# TYPE II DEVELOPMENT & ENVIRONMENTAL REVIEW, STAFF REPORT & DECISION

139<sup>th</sup> STREET PLAZA

PLD2009-00050;

The applicant is proposing to divide approximately 4.68 acres located in an ML (Light Industrial) zoning district into four (4) parcels. The applicant is also requesting site plan approval for a 4,000 square foot existing automotive repair shop on Lot 1, a 4,900 square foot quick lube auto service building on Lot 2, a 4,980 square foot automotive repair shop on Lot 3, and a 29,850 square foot mini-storage facility on Lot 4.

Copy of Proposed Preliminary Plan

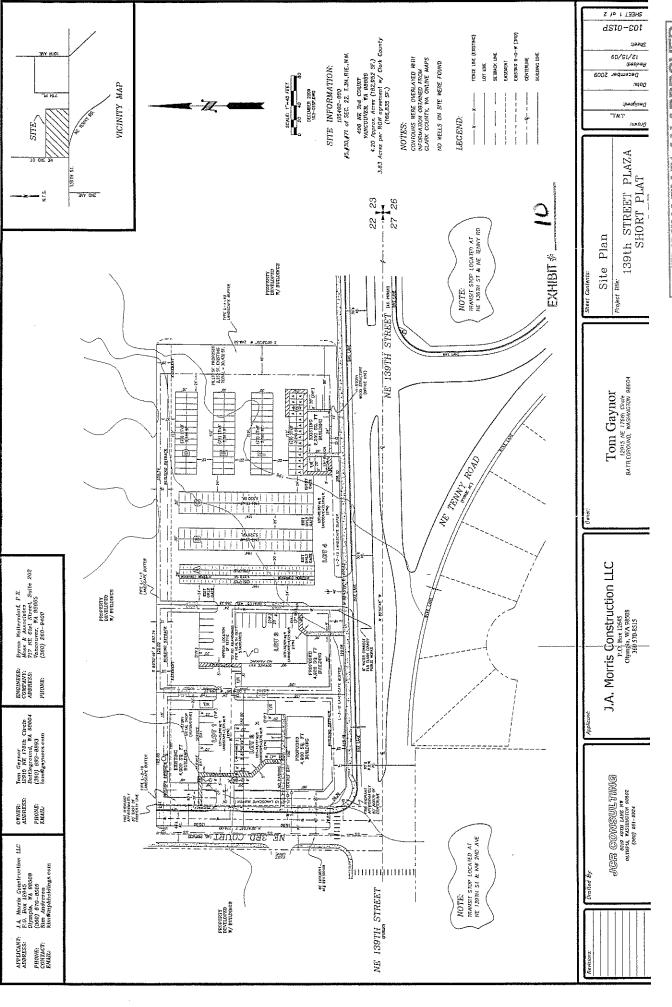
A review of the revised plan [Exhibit 10] reveals that all four (4) proposed lots meet the above standards.

Based on the above formulas, the following table identifies the required number of parking spaces and what is being shown on the revised preliminary plan [Exhibit 10] for each lot:

Accessible parking spaces shall be provided in compliance with the Americans with Disability Act (ADA). Based on the number of parking stalls on each lot, one van accessible handicap space is required on each resulting parcel. The revised plan [Exhibit 10] shows the prerequisite number of spaces. However, there is a question whether or not these spaces meet dimensional requirements (See Building Safety Finding 1 and Condition A-10-a).

Based on a cursory calculation by staff, it is unclear whether or not each resulting lot meets this standard. Neither the revised site plan [Exhibit 10] nor the landscape plan [Exhibit 1, Tab 29] notes the amount of landscaping provided for each individual lot. This oversight shall be corrected on the final landscape (See Condition A-2-a).

The landscape plan does not match the layout of the shared parking area for Lot 1 and Lot 2 as shown on revised site plan [Exhibit 10]. For 21 parking spaces, three (3) landscape islands are required. For Lot 3, said plan shows two (2) islands. However, three (3) landscaped islands are prescribed for the 16 stalls being proposed. In addition, the applicant has not identified a planting scheme so staff is unable determine if the islands contained the necessary tree. These deficiencies shall be corrected on the final landscape plans for each resulting lot (See Condition A-2-b and A-2-c).

The revised preliminary site plan [Exhibit 10] shows the required pedestrian paths. Where the walkway crosses or is adjacent to a vehicular maneuvering area, however, the plan does not specify the type of demarcation that will be utilized. This deficiency shall be corrected on the final site plan for each respective lot (See Condition A-1-f).

The revised site plan [Exhibit 10] shows that each resulting lot has a designated trash receptacle area. Based on available information, staff is unable to determine that the area being provided meets the above requirements. A condition will, therefore, be imposed that compliance with solid waste storage standards shall be demonstrated (See Condition A-1-g).

The revised site plan [Exhibit 10] shows at least one (1) accessible parking space for each resulting lot. It appears that a minimum of four (4) of these spaces must be van

- A-1 Final Site Plan The applicant shall submit and obtain County approval of a final site plan for each resulting lot in conformance to CCC 40.320.040. <u>Unless a specific lot is identified, the following conditions of approval apply to all lots within this short plat:</u>
  - **a.** Lot 3: Access to this lot across one of the adjacent parcels within this short plat shall be constructed. (See Land Use Finding 2)
  - **b.** Lot 1: There shall be a minimum of 8 parking spaces to serve the existing automotive repair facility prior to recordation of the final plat. This may result in the construction of at least 3 of the shared parking spaces located on Lot 2. (See Land Use Finding 5)
  - c. Lot 1: An agreement for shared parking between Lot 1 and Lot 2 of this short plat shall be submitted for review. Once approved by the Prosecuting

- A-2 Final Landscape Plan The applicant shall submit and obtain county approval of final landscape plan. <u>Unless a specific lot is identified, the following conditions</u> of approval apply to all lots within this short plat:

- a. The landscape plan for each respective lot shall identify the amount of landscape being provided for said lot. A minimum of fifteen percent (15%) of the lot/phase shall be landscaped. (See Land Use Finding 7)

- b. Lots 1 and 2: For 21 parking spaces, a total of three (3) landscape islands, meeting requirements set forth in CCC 40.320.010(E)(3) and (4), are required. One such island shall be provided in conjunction with the final site plan for Lot 1. (See Land Use Finding 7)

- e. The final landscape plan shall identify the location, number, species and size of trees, shrubs and/or groundcover to be planted within the prescribed buffers shown on the revised preliminary site plan [Exhibit 10]. This information shall also be provided for any existing landscape material to be retained. (See Land Use Finding 8)

a. The final site plan for each individual lot shall show sufficient detail to demonstrate that the required van accessible spaces meet dimensional requirements for said spaces. (See Building Safety Finding 1 and Land Use Finding 5)
